DART SERVICE INSTRUCTION

TO AMEND INSTALLATION INSTRUCTIONS D206-558 &
INSTRUCTIONS FOR CONTINUED AIRWORTHINESS ICA-D206-558

REF TCCA STC SH92-17

FAA STC SH1031NE

FIGURE 1 - BRACKET SUBSTITUTION

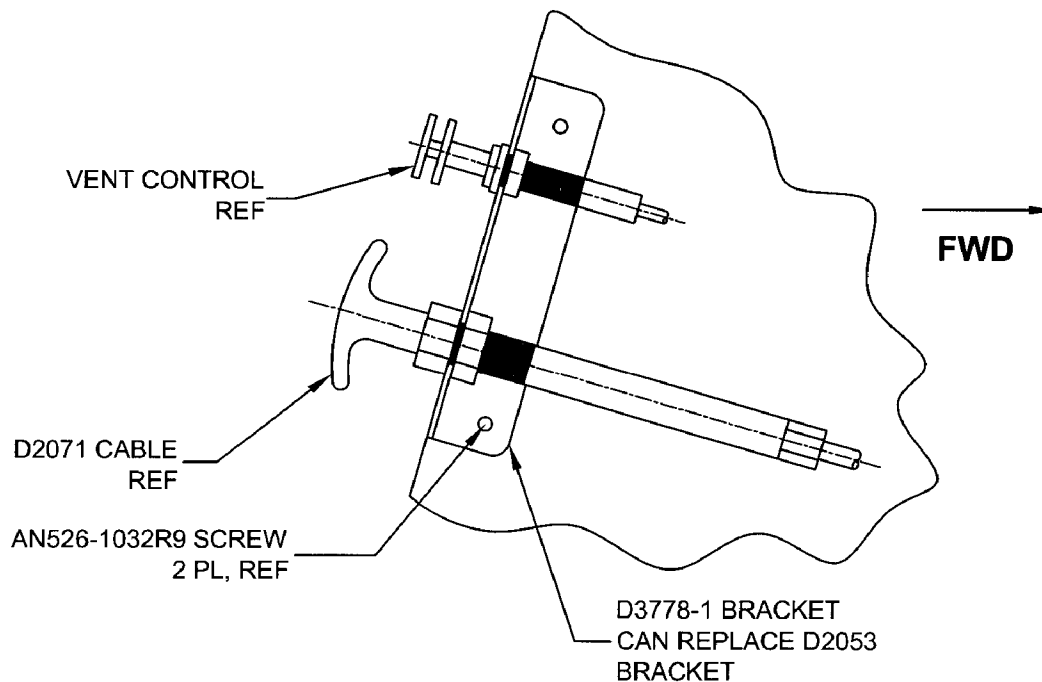
FOR D206-558-041/-043 AT CHG 006 OR LATER, THE D3778-1 BRACKET HAS BEEN ADDED TO THE KITS TO ALLOW FOR INSTALLATION OF THE VENT CONTROL. THE D2053 BRACKET CAN BE REPLACED BY THE D3778-1 BRACKET AS DESCRIBED BELOW:

- 1) IF INSTALLED, REMOVE THE EXISTING VENT CONTROL BRACKET AND REMOVE THE VENT CONTROL.
- 2) PICKING UP ON EXISTING ANCHOR NUTS, INSTALL THE D3778-1 BRACKET USING AN526-1032R9 SCREWS.
- 3) INSTALL THE VENT CONTROL IN THE UPPER SLOT. INSTALL THE D2071 CABLE IN THE LOWER SLOT.
